DESIGN CB	DRAWN BY CB	<b>DART AEROSPACE LTD</b> HAWKESBURY, ONTARIO, CANADA	
CHECKED PH	APPROVED [Signature]	DRAWING NO. DSI 9180	REV. B SHEET 1 OF 1
DATE 06.07.12		TITLE TOW RING	SCALE NTS
A	00.03.08	NEW ISSUE	
B	06.07.12	AN970 WAS AN960

## DART SERVICE INSTRUCTION

TO AMEND INSTALLATION INSTRUCTION D205-634 REV. B AND  
INSTALLATION INSTRUCTION D204-635 REV. B  
REF. CANADIAN STC: SH96-88  
FAA STC: SR00563NY

**Figure 1 – Tow Ring Amendment**

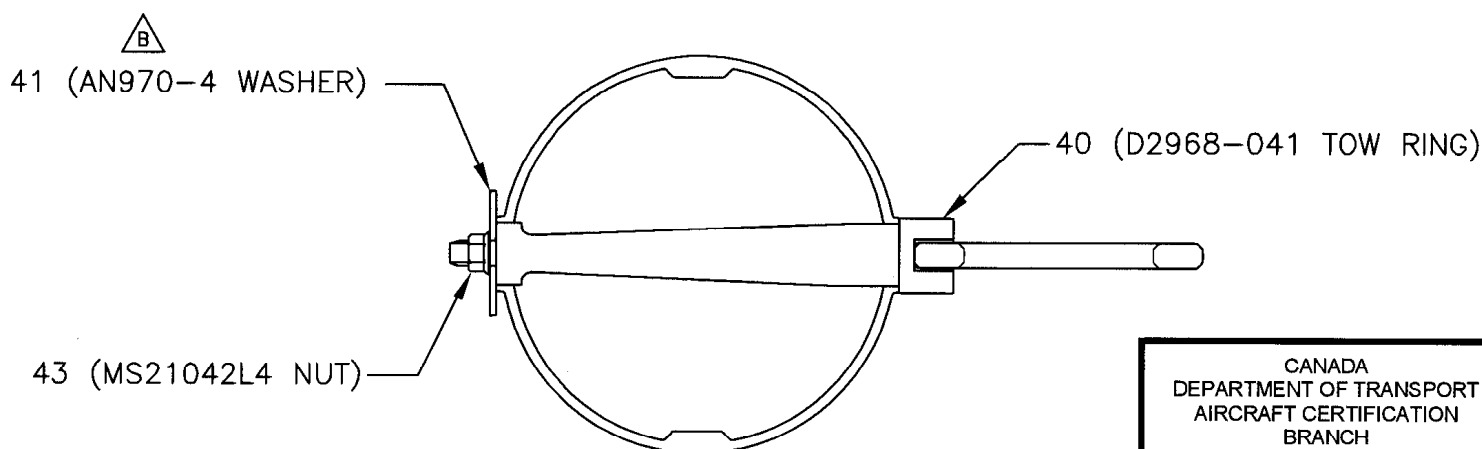
TO AMEND THE INSTALLATION INSTRUCTIONS PARTS LIST ON PAGE 7 OF D205-634 REV.B AND D204-635 REV.B:

TO AMEND INSTALLATION INSTRUCTIONS PROCEDURE STEP 2 OF D205-634 AND D204-635:  
Install tow ring as shown below:

Replace:

Item	Qty	Part No.	Description
40	1	D2707-041	TOW RING
42	1	AN960JD1016	WASHER

With:

Item	Qty	Part No.	Description
40	1	D2968-041	TOW RING
